Access Compliance Report Public Rights-of-Way (Curb Ramps)

Intersection ID: 10031467 Main Street: MCGINN'S_TRACE_CT Cross Street: N/A Location: SE

ADA ID: 15EEACAC6027 Ramp Type: Perp Initial Pass/Fail: Fail Overall Compliance: No Severity Score: 12.5

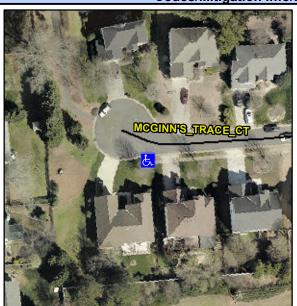
R304.2.2

Compliance Description Date		Data	0	lianas Dasanintian	Date
Compliance Description		Data	Compliance Description		Data
N/A	Ramp Length (in)	47.0	No	Ramp Slope (%)	10.3
Yes	Ramp Width (in)	59.0	Yes	Ramp XSlope (%)	0.5
N/A	Flare Type LT	N/A	N/A	Flare Type RT	N/A
N/A	Flare Slope LT (%)	N/A	N/A	Flare Slope RT (%)	N/A
N/A	Flare Traversable LT?	N/A	N/A	Flare Traversable RT?	N/A
N/A	Landing Length (in)	N/A	N/A	DWS Provided?	N/A
N/A	Landing Width (in)	N/A	N/A	DWS Contrast?	N/A
N/A	Landing Slope (%)	N/A	N/A	DWS Length (in)	N/A
N/A	Landing X Slope (%)	N/A	N/A	DWS Full Width?	N/A
N/A	Landing Curb? (Y/N)	N/A	N/A	DWS Offset (in)	N/A
N/A	Shared Landing?	N/A			
N/A	Gutter Ponding?	N/A	N/A	Gutter Slope (%)	N/A
N/A	Gutter Lip Ht (in)	N/A	N/A	Gutter X Slope (%)	N/A
N/A	Painted X Walk1?	No	N/A	Painted X Walk2?	N/A
	X Walk 1 Direction	To N		X Walk 2 Direction	N/A
N/A	X Walk 1 Width (in)	N/A	N/A	X Walk 2 Width (in)	N/A
	X Walk 1 Slope (%)	0.3		X Walk 2 Slope (%)	N/A

Remove & Replace Entire Ramp.
